**Waimea Water Augmentation  
Committee**

**Lee Valley Dam  
Detailed Design Report Stage 3**

**October 2012 (revised July 2014)**

**T&T Ref: 27425.100 Resource Consent Issue**

Figure above shows the Stage 1 design commented upon. Differential settlements at the perimetric joint were a potential issue.

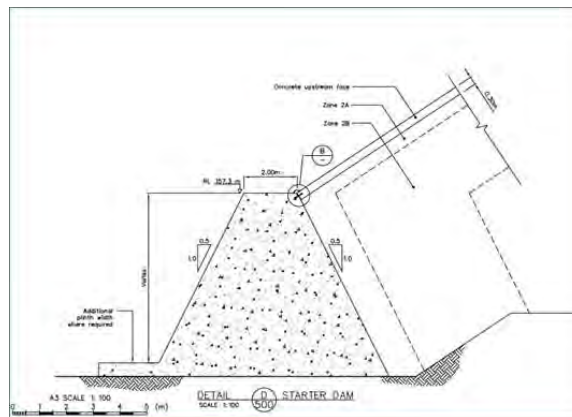
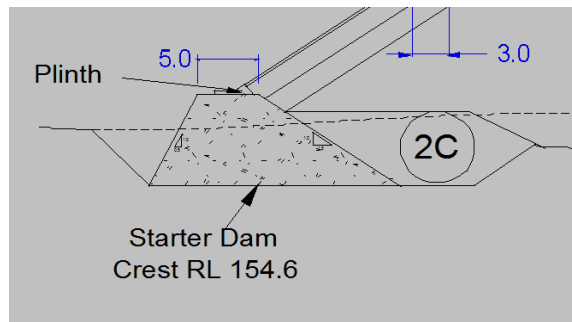
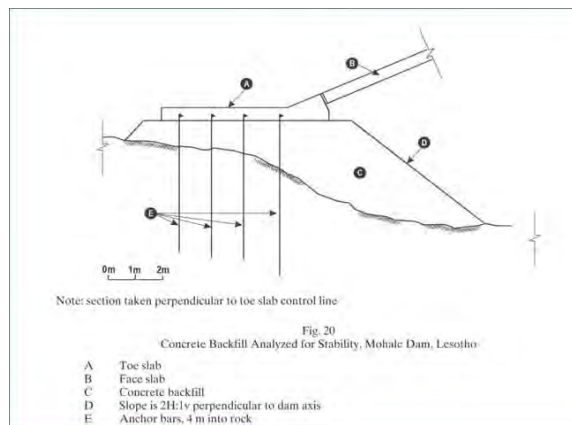
The perimetric joint detail at the starter dam (dwg 250) indicates that the supporting internal formed face slope is other than perpendicular to the membrane plane immediately below the joint. Supporting detail needs to be provided to show the performance of the joint under severe seismic loading will not be compromised by this design.

This detail has been refined.

The design has changed substantially since Stage 1. See figure below.

The Stage 3 design shown below has a downstream slope of 1.5h:1v and is backfilled with relatively stiff alluvial gravels. The combined effect of the stiffer backfill material and flatter starter dam backslope is expected to keep differential movement between the face slab and the starter dam to acceptable levels. In accordance with ICOLD B141 guidelines it avoids a high fill depth adjacent to the perimetric joint and provides a gradual increase in fill thickness with distance from the joint.

It is also similar to configurations adopted for the Mohale Dam plinth – See figure below.
